## Economic Commission for Europe

#### Joint Meeting of Experts on the Regulations annexed to the European Agreement concerning the International Carriage of Dangerous Goods by Inland Waterways (ADN) (ADN Safety Committee)

### **Consolidated version (taking into account the corrections from document ECE/TRANS/WP.15/AC.2/2016/30 corr. 1)**

### **Proposal for the implementation of the modified explosion protection concept on inland water way vessels**

# Zoning on Tank Vessels

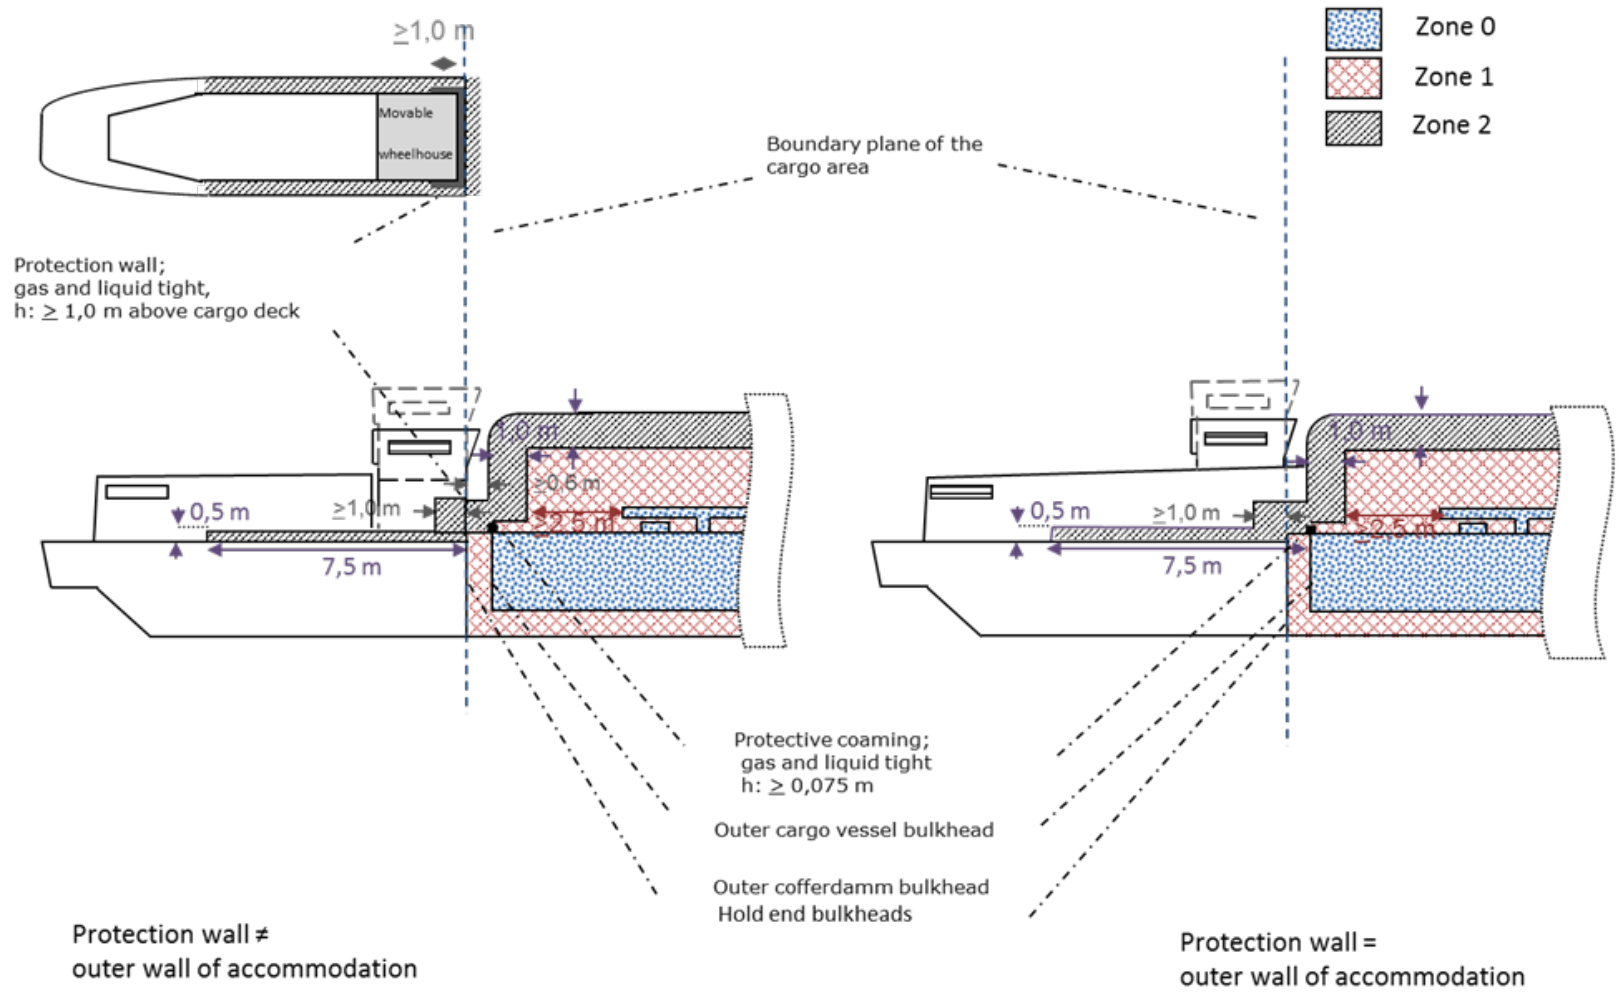
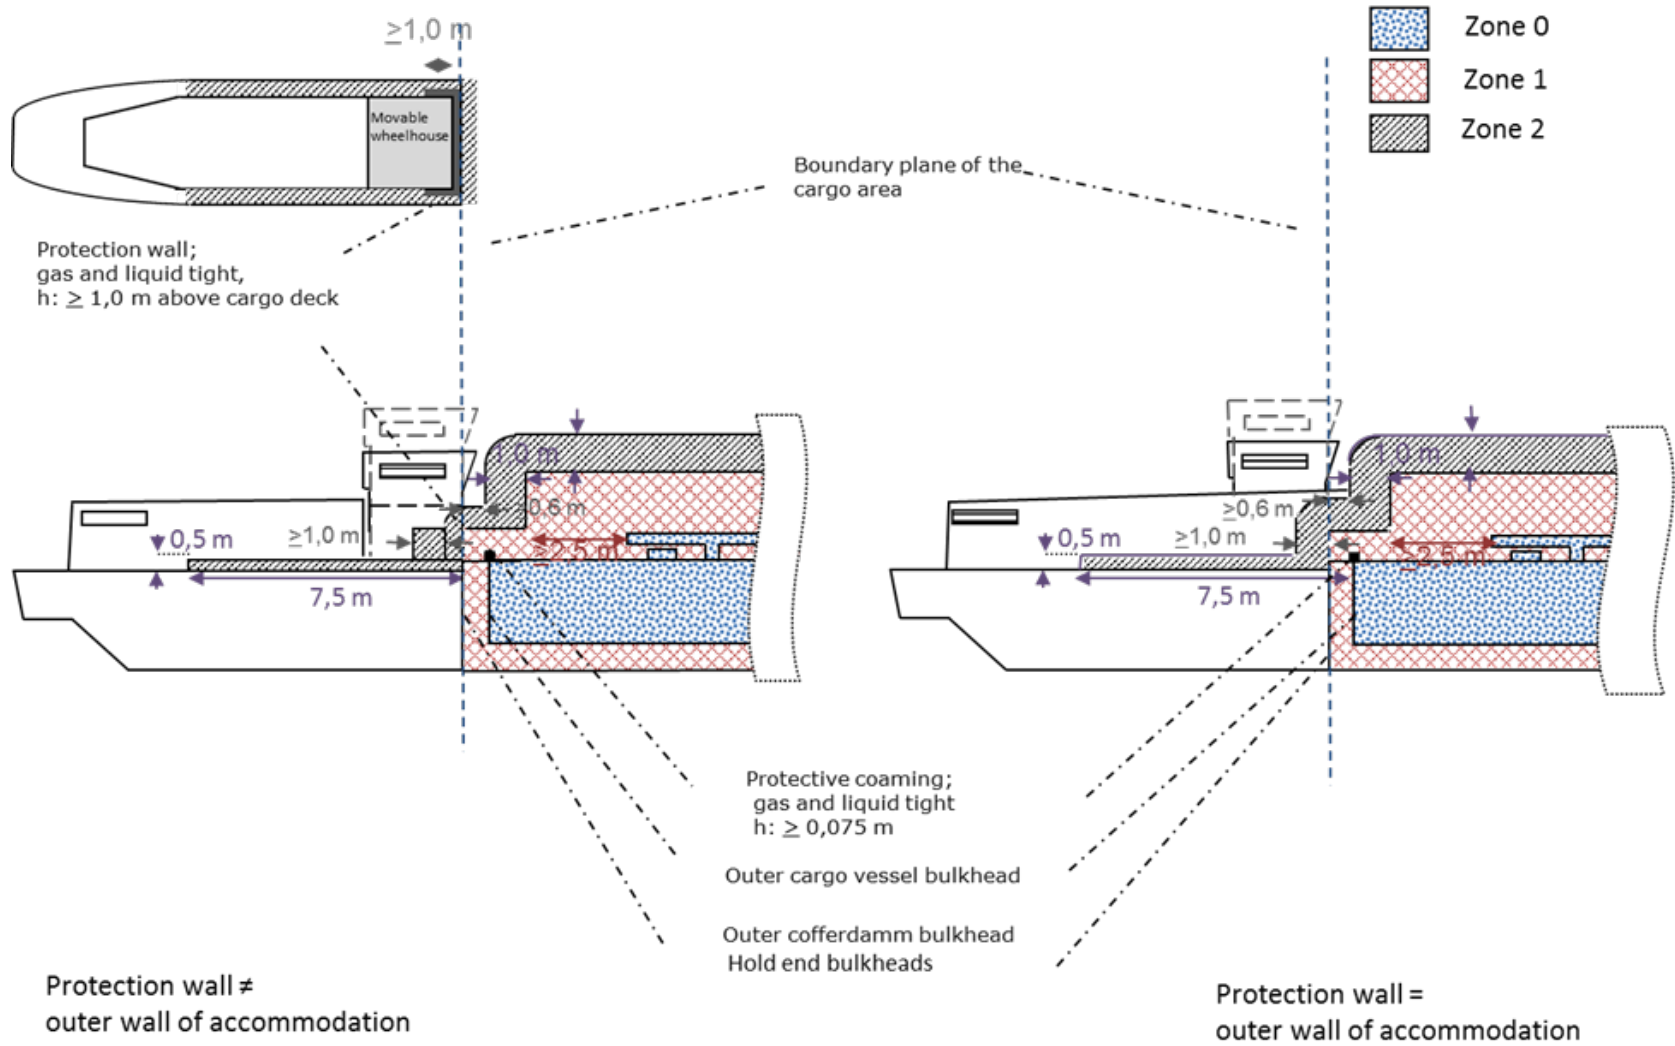
<p><i>Zoning</i> <i>Classification des zones</i> <i>Zoneneinteilung</i> <i>Классификация зон</i></p>	<p>This zoning (see drawing) applies for tank vessels whose vessel substance list according to <u>1.16.1.2.5 contains substances for which explosion protection is required in column (17) of Table C of 3.2.3.2</u></p> <p><b>Zone 0:</b> comprises:</p> <p> - <u>Inside all cargo tanks, receptacles for residual products and for slops, pipings containing cargoes or cargo vapours including their equipment as well as pumps and compressors.</u></p> <p><b>Zone 1:</b> comprises:</p> <p> - <u>All compartments within the part of the cargo area below deck being not part of zone 0.</u></p> <p>- <u>Closed compartments on deck within the cargo area.</u></p> <p>- <u>The deck from one side of the vessel to the other within the cargo area up to the cofferdam bulkheads.</u></p> <p><u>Up to a distance of at least 1.6 m to the boundary plane of the cargo area the height is 2.5 m above deck, at least, however, 1.5 m above the highest piping carrying cargoes or cargo vapours.</u></p> <p><u>Whereas every opening in zone 0 except the high velocity vent valves / safety valves of pressurized cargo tanks shall be surrounded by an annulus zone 1</u></p>	<p>New zone concept New definition ADN wording 2x</p>

<p><u>having at least a width of 2.5 m. With openings the diameter of which is less than 0.026 m (1") the distance to the outer cofferdam bulkhead can be reduced to 0,5 m, provided it is ensured that such an opening is not opened to the atmosphere within this distance.</u></p> <p><u>Adjacent (fore and aft) till the outermost cargo tank shots the height is 0.25 m above deck.</u></p> <p><u>If the ship is build with hold spaces or a cofferdam/ part of a cofferdam is arranged as a service space the adjacent height (fore and aft) till the boundary plane of the cargo area is 1.0 m above deck (see drawing).</u></p> <ul style="list-style-type: none"> <li>- <u>An area surrounding cylindrically the high velocity vent valve/safety valve of pressurized cargo tanks with a radius of 3.0 m up to a height of 4.0 m above the opening of the high velocity vent valve/safety valve of pressurized cargo tanks.</u></li> <li>- <u>A spherical segment surrounding the ventilation openings of the service spaces located within the cargo area which are actively ventilated, comprising a radius of 1.0 m centered over the opening.</u></li> </ul> <p><b>Zone 2:</b> comprises:</p> <ul style="list-style-type: none"> <li>-  <u>An area on deck within the cargo area of 1.0 m in height and length following zone 1.</u></li> <li>- <u>On the fore deck and the aft deck an area of the entire width of the vessel adjacent to boundary plane of the cargo area, with a complete length of 7.5 m. Between the lateral side of the vessel and the protection wall this area equals the length and height of the dimensions of the lateral side of the protection wall. Apart from that, the height is 0.5 m.</u></li> </ul> <p><u>This part is not part of zone 2 in case the protection wall extends from one side of the vessel to the other and there are no openings.</u></p> <ul style="list-style-type: none"> <li>- <u>An area following zone 1 around the high velocity vent valve/safety valve of pressure cargo tanks having an expansion of 3.0 m.</u></li> <li>- <u>A spherical segment following zone 1 which surrounds the ventilation openings of the service spaces located within the cargo area which are actively ventilated, comprising a radius of 1.0m centred over the opening.</u></li> </ul>	<p>Aligning language versions</p>
